27th July 2023

Re: Parramatta Light Rail Stage One

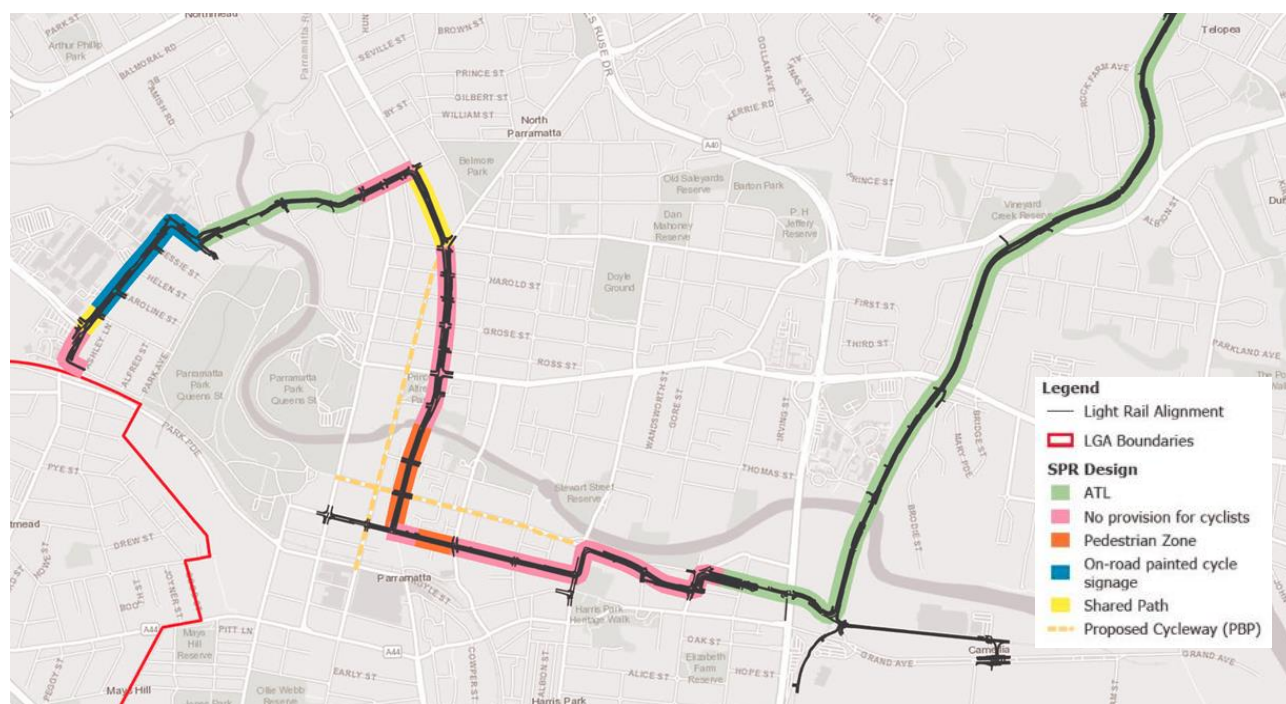
The CBD is now shaking off the rubble. It is clear that Parramatta Light Rail Stage One still excludes bicycles from large parts of the Parramatta CBD (Figure 1). This undermines the great good that can be achieved by the transformation of traffic sewers into multi-modal transport corridors.

Cycling has been permanently banned from sections of Macquarie Street and Church Street where vehicle lanes have been removed. People need to use the streets with light rail tracks to reach their final destinations. Directing bike riders to dismount can be dangerous in traffic or when manoeuvring heavy cargo bikes. Inconvenient and disconnected journeys discourage cycling, limiting the mode shift that recent NSW Government strategies and policies aim to achieve.

To create alternative east-west and north-south routes through the CBD, City of Parramatta is developing cycleways on Marsden Street and George Street (Figure 1) in accordance with the [2017 Parramatta Bike Plan](#). This will involve reallocating vehicle space to create separated bicycle paths that will be suitable for a wide range of riders of all ages and abilities. However, bike riders will need to cross the light rail tracks to access these cycleways.

- identify the intersections where 'No Bicycles' and 'Cyclist Dismount' signs need to be removed to facilitate both cycle movements across the CBD and safe access by bike to all important destinations within the centre.

- investigate and trial track inserts where the angle of the tracks creates a risk of wheel entrapment for bikes and wheelchairs. There are translatable technologies that have been developed in different parts of the world to make tram tracks safer for vulnerable road users.
- develop solutions to allow bike riders to legally ride along all Parramatta CBD streets, including streets with light rail tracks. Every street has shops, restaurants, workplaces, public transport stops or schools that bike riders need to reach. For example, businesses in 'Eat Street' and Macquarie Street require access for bike couriers and food delivery workers.
